ADDENDUM NUMBER ONE

Bids Received until
2:00 P.M. CDT November 17, 2011
Hoover City Schools Board of Education
2810 Metropolitan Way
Hoover, Alabama 35243

Harold L. Foshee Architects
345 Highgate Hill
Indian Springs,
Alabama 35124

**ADDITIONS TO
HOOVER HIGH SCHOOL
HOOVER, ALABAMA**

ADDITIONS TO
HOOVER HIGH SCHOOL
HOOVER, ALABAMA
Revise Drawing Sheet No. A7.1, A7.2

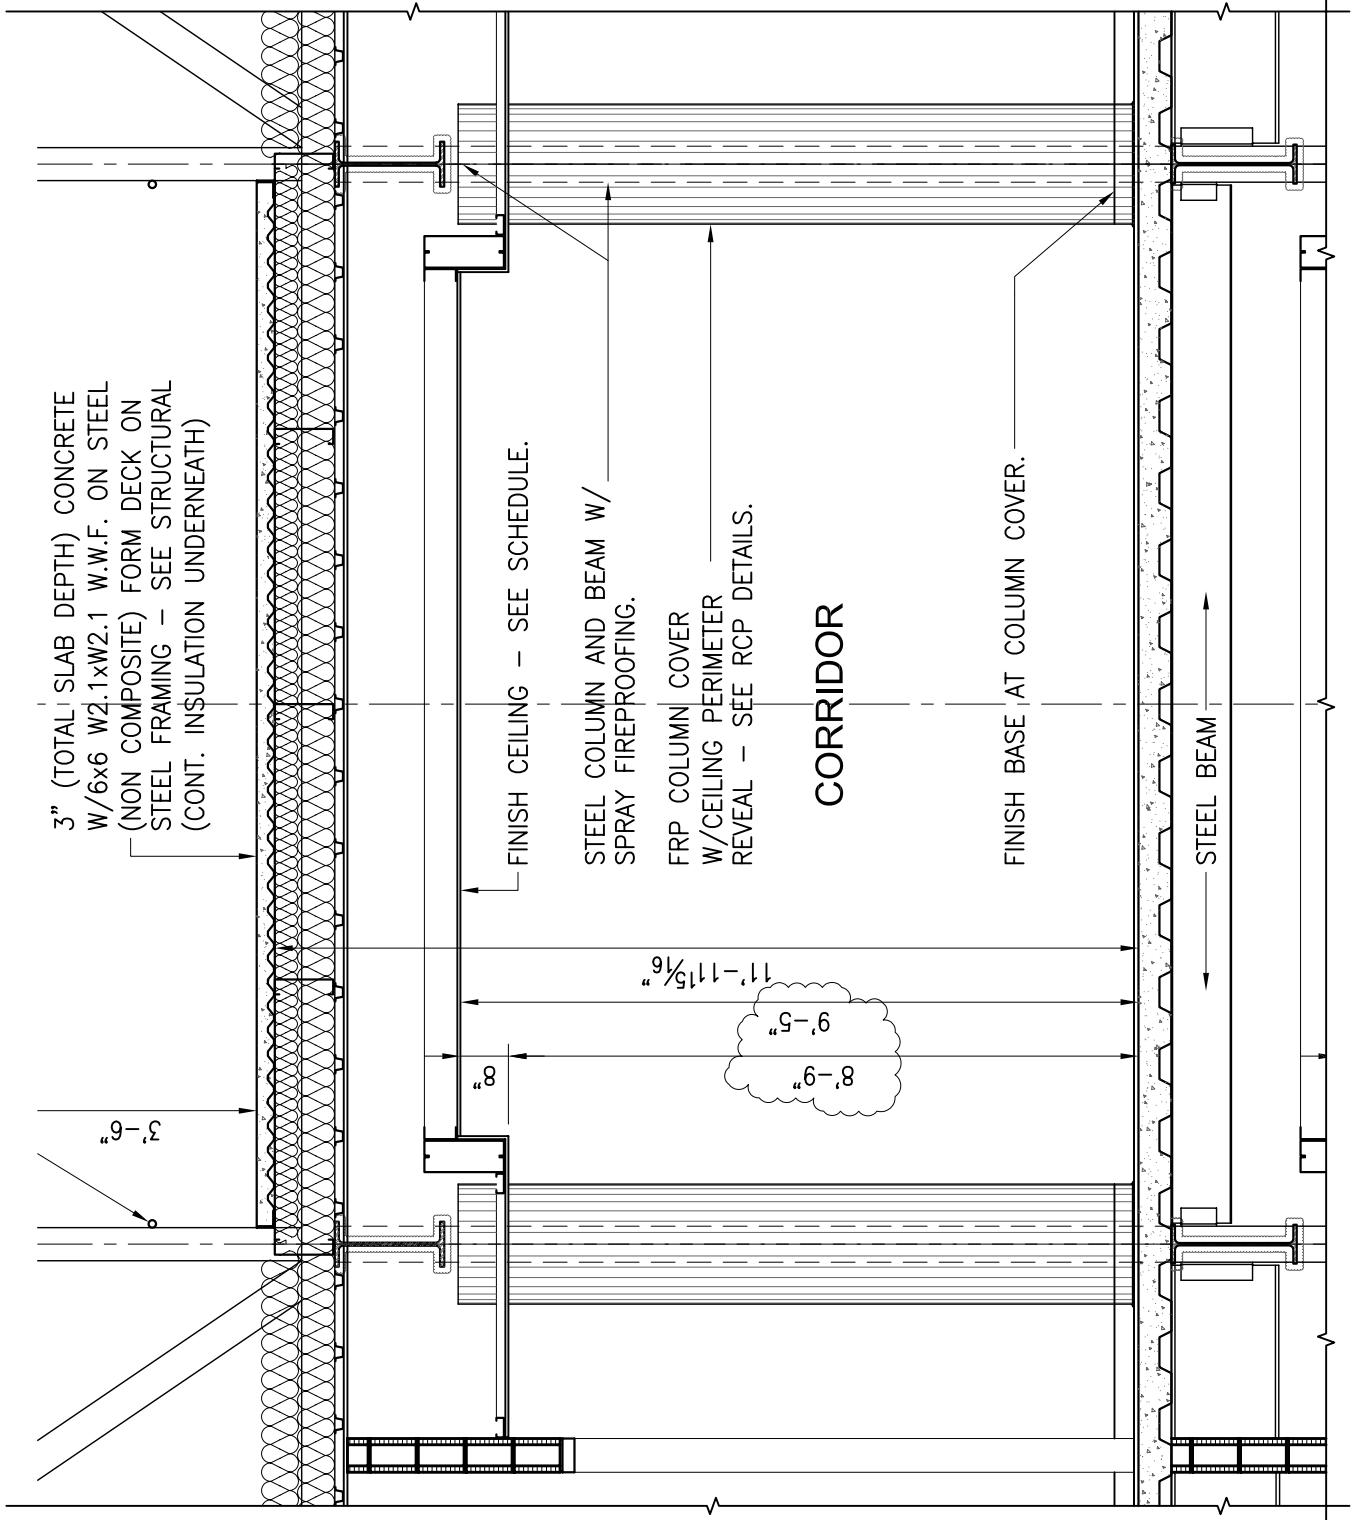
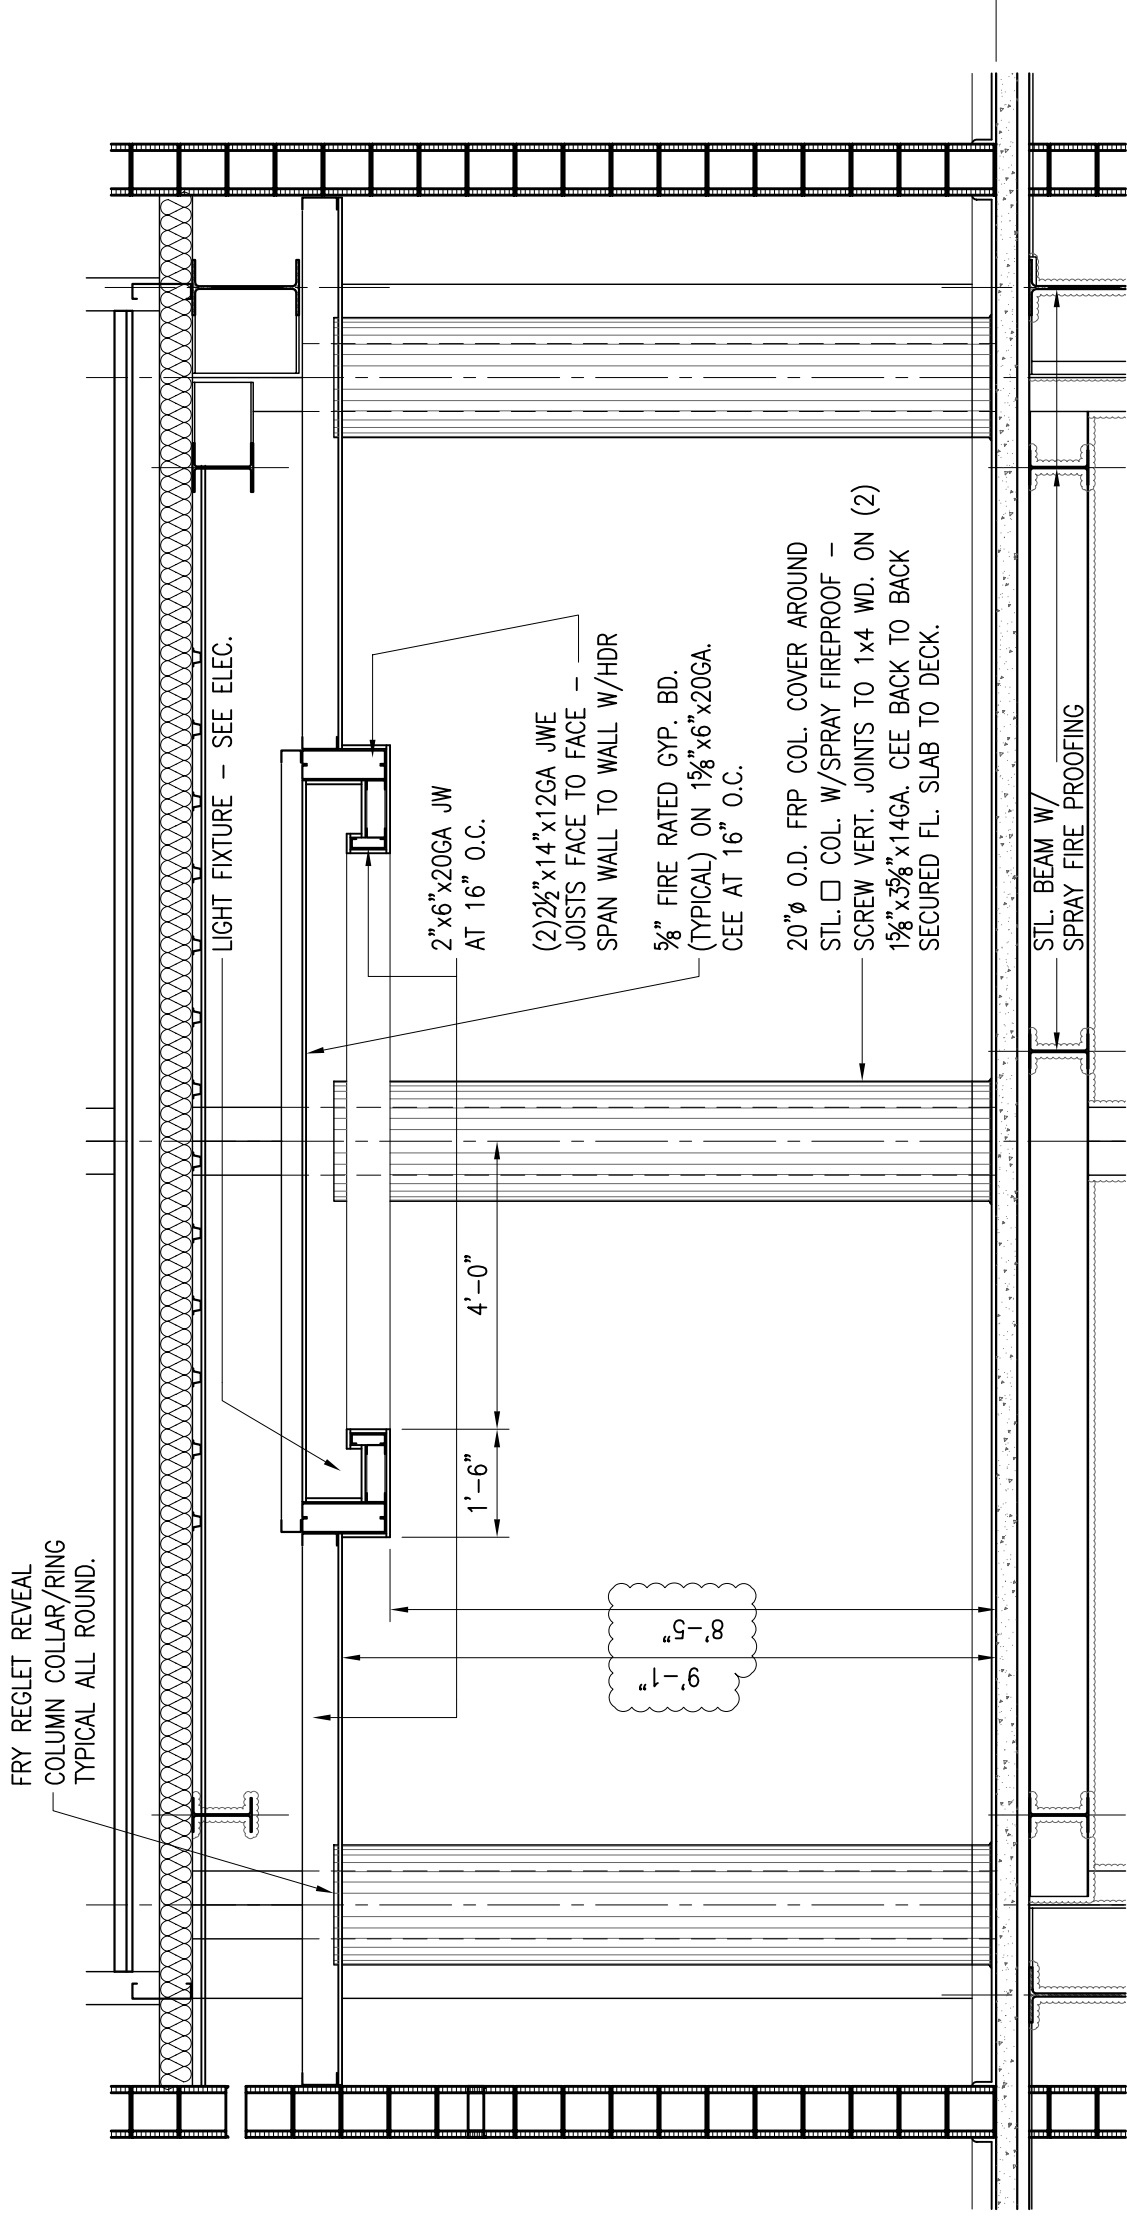
D1.4 Sheet No. A3.1, A7.1, A7.2:

A. Change ceiling heights in corridor G300A and G300B as shown.. See Attachment SD-5 and SD-6.

Revise Drawing Sheet No. A3.1

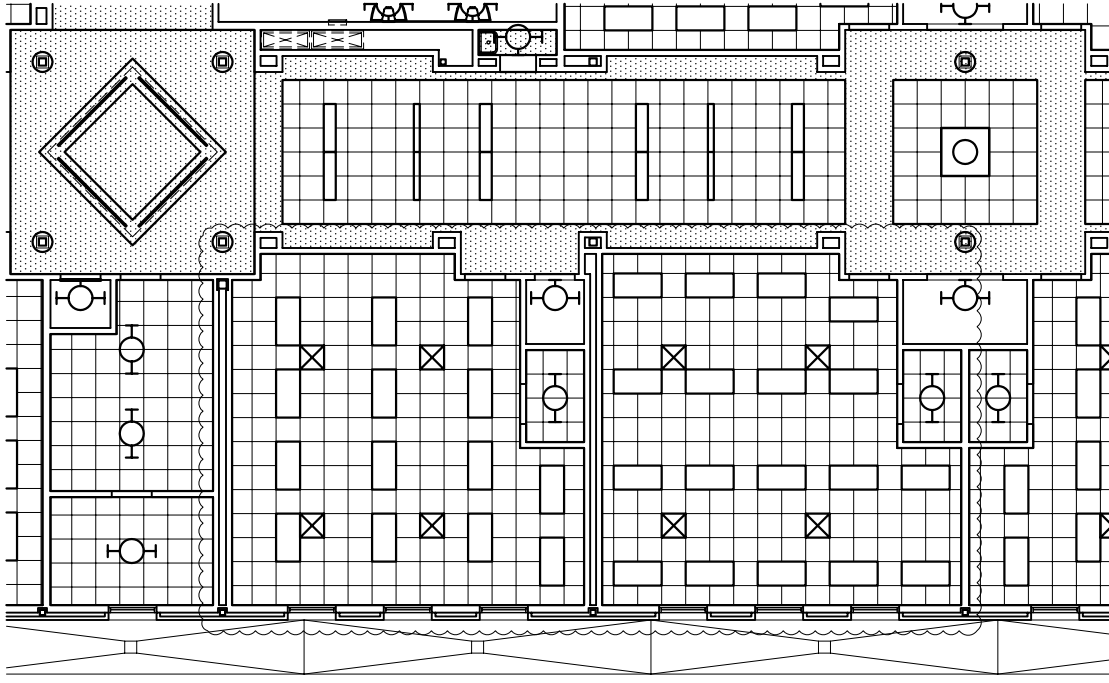
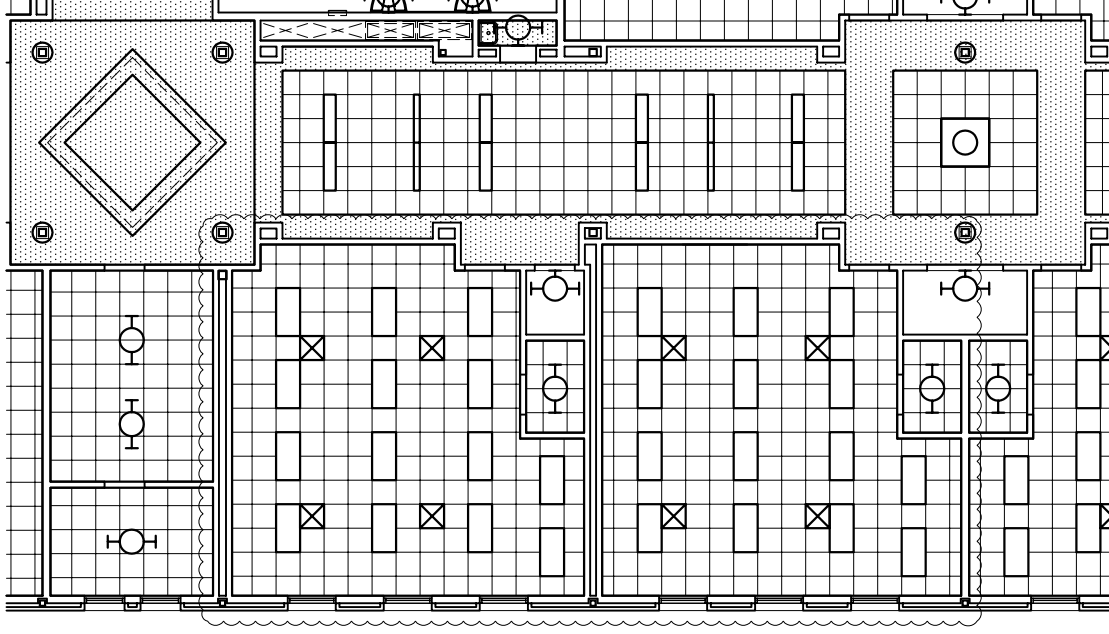
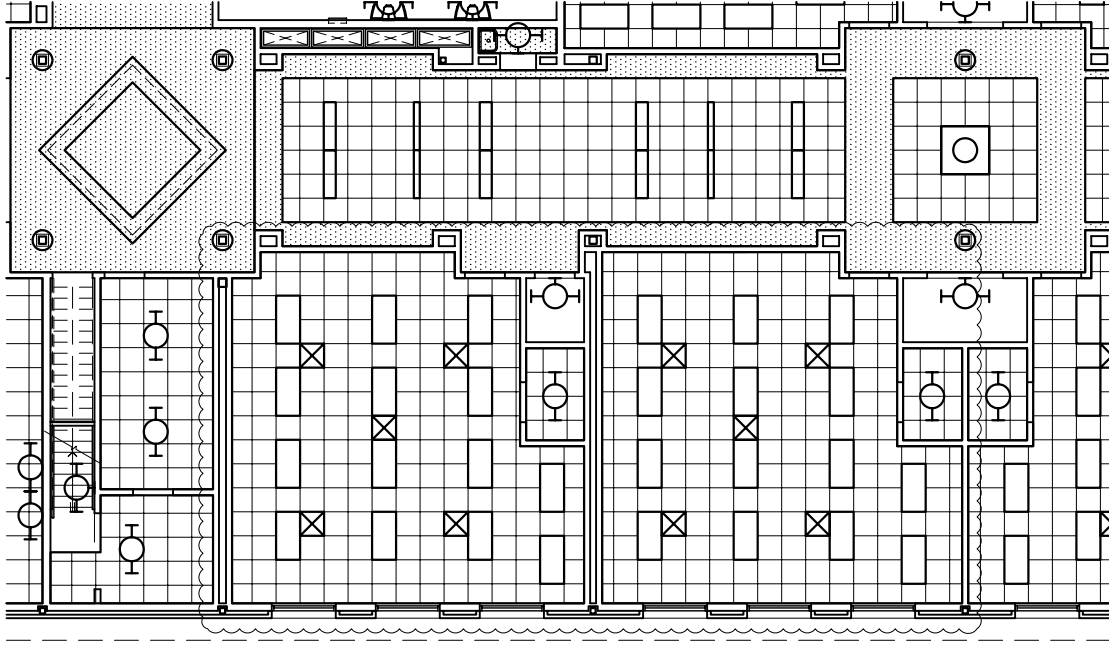
A. Added double walls at Column AD and between Columns 1' & 2. See Attachment SD-4 & SD-7.

DRAWING NO.: SD-E1

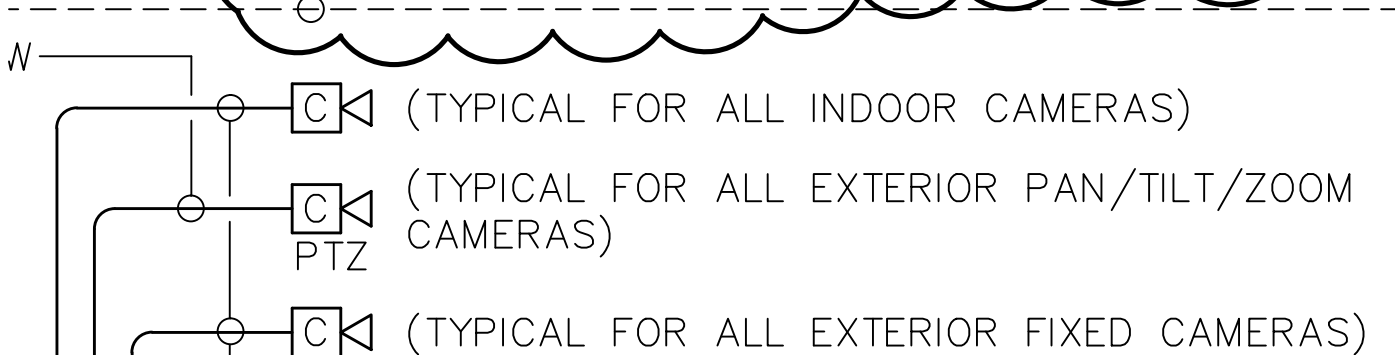
D1.23 Sheet No. E1.1:

A. Change electrical notes as shown. See attachment SD-E1.

7. THIS CONTRACTOR SHALL COORDINATE ALL PENETRATIONS THROUGH UPPER LEVEL FLOOR SLABS WITH STRUCTURAL. CONTRACTOR SHALL PROPERLY FIRE STOP AROUND ALL FLOOR TO FLOOR PENETRATIONS.

8. ALL ELECTRICAL PANELBOARDS AND SWITCHBOARDS SHALL BE PROVIDED WITH FULL A.I.C. RATINGS AS SPECIFIED IN THE PANELBOARD SCHEDULES SHOWN ON THE DRAWINGS. SERIES RATING OF POWER DISTRIBUTION EQUIPMENT IS NOT ALLOWED. ALL PANELBOARDS AND SWITCHBOARDS MAY BE PROVIDED WITH TIN PLATED ALUMINUM BUSSING.

9. CONTRACTOR SHALL SUBMIT 1/4" = 1'-0" DRAWINGS SHOWING PROPOSED LAYOUTS OF ALL ELECTRICAL DISTRIBUTION EQUIPMENT IN ELECTRICAL ROOMS WITH SHOP DRAWINGS.

10. PANEL DIMENSIONS SHALL NOT EXCEED THE SIZES SHOWN ON PLANS WITHOUT SPECIFIC PERMISSION FROM THE ENGINEER.
11. THIS CONTRACTOR SHALL RE-USE EXISTING SPARE BREAKERS AND PROVIDE NEW BREAKERS WITHIN EXISTING PANELS PP-EM, RP-K1, LP-F1, RP-EM-A1 AND LP-EM-F1 AS NECESSARY TO ACCOMMODATE NEW BRANCH CIRCUITS SHOWN ON DRAWINGS. CIRCUIT NUMBERS AS SHOWN ON DRAWINGS ARE FOR REFERENCE PURPOSES ONLY. PANEL DIRECTORY CARDS SHALL BE RE-TYPED TO INDICATE ALL CONNECTED CIRCUITS. NEW CIRCUIT BREAKERS ADDED TO THESE EXISTING PANELS SHALL HAVE AN AIC RATING EQUIVALENT TO THE AIC RATING AS DETERMINED FROM THE SHORT CIRCUIT STUDY.

12. PROVIDE NEW ENGRAVED NAMEPLATES FOR ALL BRANCH CIRCUIT BREAKERS ADDED TO EXISTING MAIN SWITCHBOARD MSBB. NEW CIRCUIT BREAKERS SHALL BE RATED 100KAIC MINIMUM.

13. PROVIDE NEW ENGRAVED NAMEPLATES FOR ALL FUSIBLE SWITCHES ADDED TO EXISTING MOTOR CONTROL CENTER MCC-H. NEW SWITCHES SHALL BE RATED 100KAIC MINIMUM.

14. ALL LOW VOLTAGE CABLING NOT INSTALLED IN CONDUIT SHALL BE PLENUM RATED CABLING. LOW VOLTAGE CABLING WHERE SPECIFIED ON THE DRAWINGS AND WITHIN THE SPECIFICATIONS BY WAY OF NON-PLENUM CATALOG NUMBERS SHALL BE CONVERTED TO ITS PLENUM RATED EQUIVALENT WHEN NOT INSTALLED IN CONDUIT.

DRAWING NO.: SD-E2

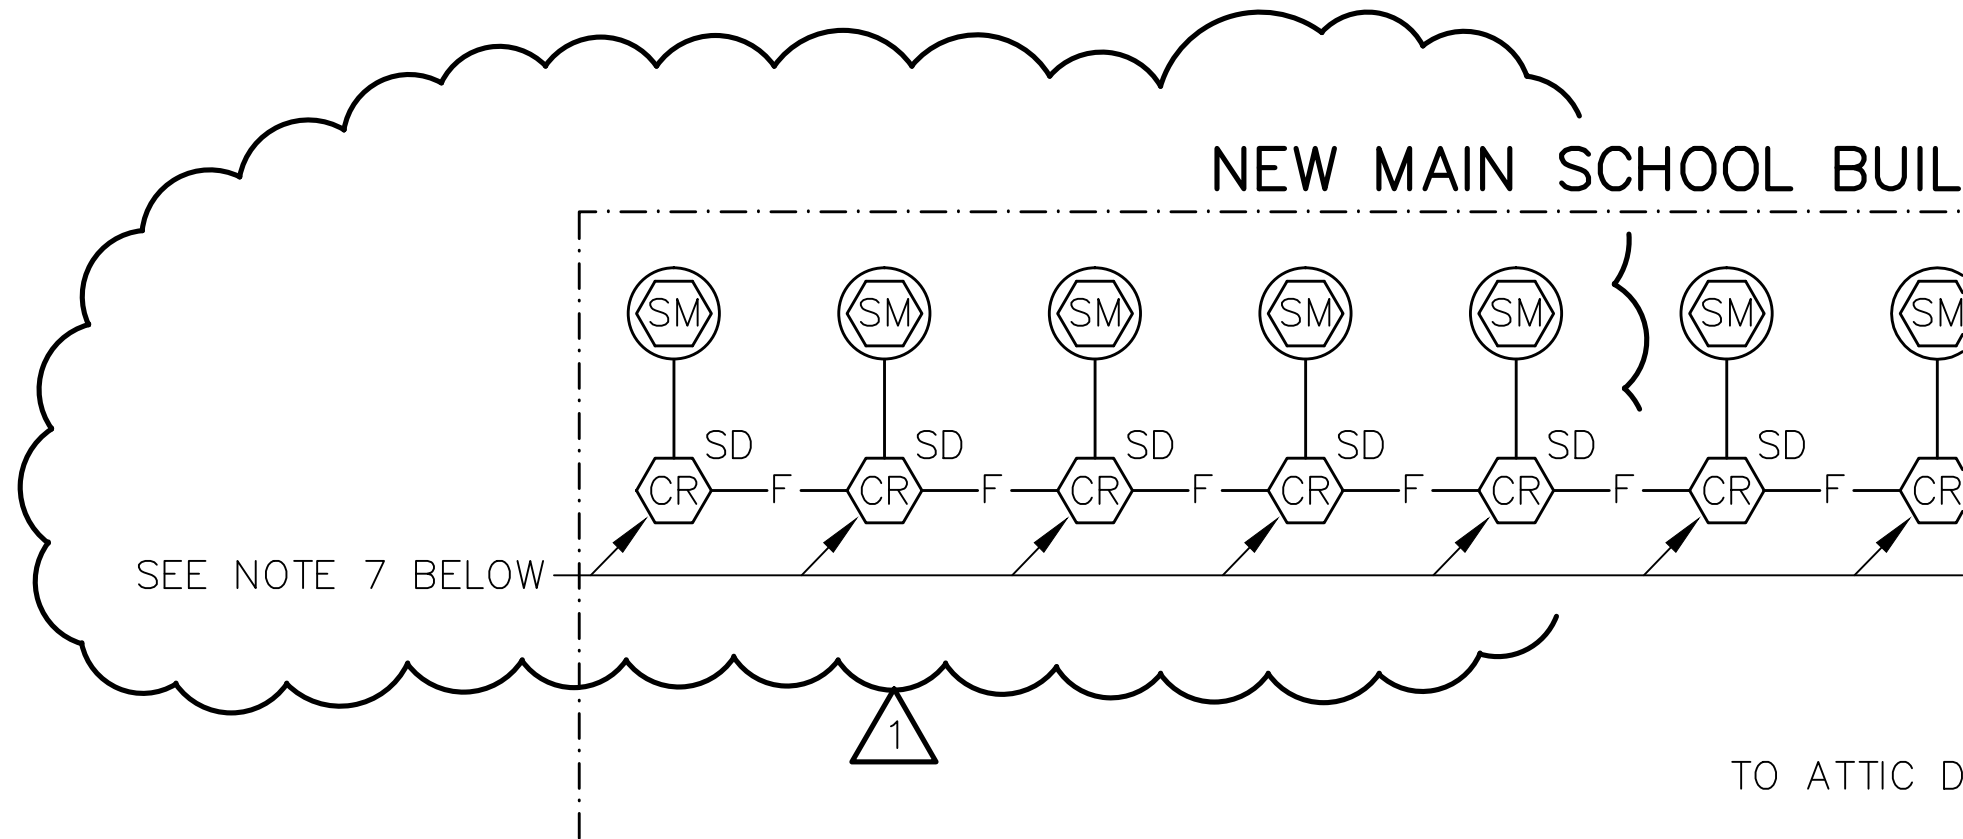
D1.24 Sheet No. E1.5:

A. Add note as shown on attachment SD-E2 and SD-E3.

ITEMS SHOWN ARE TYPICAL FOR DVR-1M AND DVR-2M (EXISTING SECURITY ROOM), DVR-MP (NEW MULTI-PURPOSE BUILDING COMM. ROOM) AND ANY OTHER DVR'S REQUIRED BY EQUIPMENT SUPPLIER

REF. SHEET: E3.2 JRA JOB NO.: 211093 DATE: 11/08/11 DRAWING NO.: SD-E5

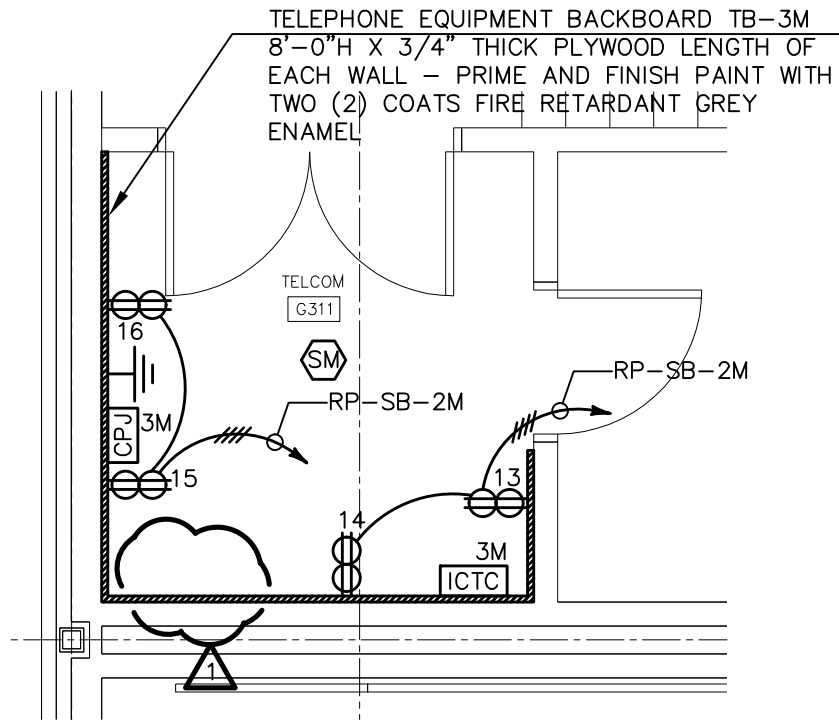
D1.26 Sheet No. E3.2:

A. Revise Second Floor Power & Auxiliary Plan as shown on attachment SD-E5.
